OHIO TURNPIKE AND INFRASTRUCTURE COMMISSION

ADDENDUM NO. 1

**BID INVITATION NO. 4210
FURNISHING PORTABLE CONCRETE BARRIER**

DATE: June 25, 2007 SCALE: N.T.S.
OTC STANDARD DRAWING XOY-3

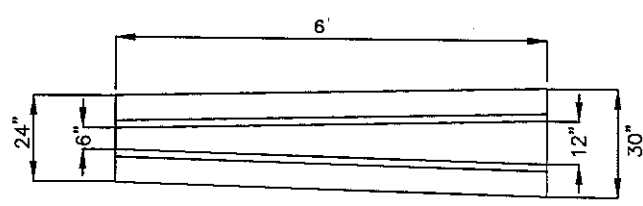
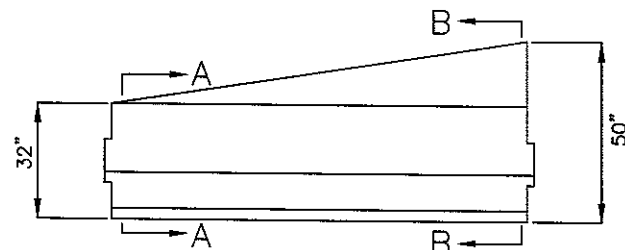
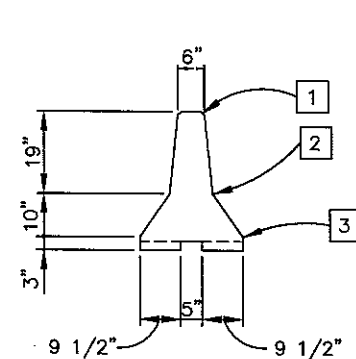
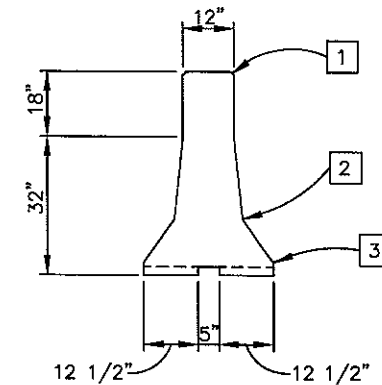
Q#3 Will you provide the details on the PCB Transition item?

Q#4 We manufacture barrier in 12' sections. Your bid form only specifies 10' sections. Shall I base my bid on the total lineal foot required 2660' which would end up being 222 pieces of 32" barrier?

A#3 With this Addendum No. 1, the Commission is providing Bidders with Standard Drawing XOV-3, referenced in the Specifications on Page 7, for the context of this Invitation to Bid. The design, including adequate reinforcing steel area and placement and concrete mix design, are left to the manufacturer's discretion to achieve the intended purpose of the Portable Concrete Barrier. See Specifications on page 7 of the Invitation to Bid.

A#4 The Commission requires ten (10) foot sections as specified. The Commission intends to use the Portable Concrete Barrier ("PCB") procured under this Invitation to replace the existing barrier wall at third-lane crossover locations. As depicted in Standard Drawing XOV-3, seventy-six (76) feet of PCB is needed, which includes the six (6) foot transition piece and seventy (70) feet of thirty-two (32) inch tall PCB constituting seven (7), ten (10) foot long sections. Because the PCB in these crossover locations is damaged from time to time, the Commission must routinely replace these PCBs. Stocking two (2) different lengths of PCB would create operational issues for the Commission when replacing damaged barriers at these crossover locations.
